Application No. 10/802,401
Amendment dated May 24, 2007
Reply to Office Action of February 28, 2007

Amendments to the Drawings

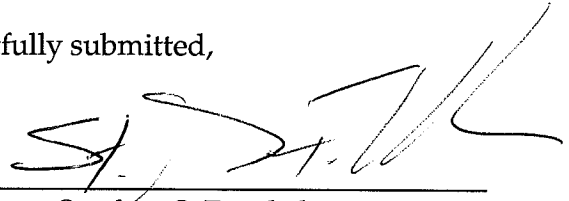
The attached annotated drawing sheet includes changes to Figure 5 to show adhesive 12 between the spoke 2 and the holding part 11, as described in paragraph [0029] of the specification.

The drawing informalities are addressed in annotated Figure 5 submitted herewith. More particularly, annotated Figure 5 now specifically shows the adhesive that may be present between the holding part 11 and the spoke 2. In addition, the adhesive is now designated with reference number 12 in annotated Figure 5, and the specification is amended in paragraph [0029] in this regard as well. With respect to the interspace of claim 4, paragraph [0024] of the specification is amended to clarify that the gap 5 between the spoke 2 and holding part 3 is the same interspace recited in claim 4.
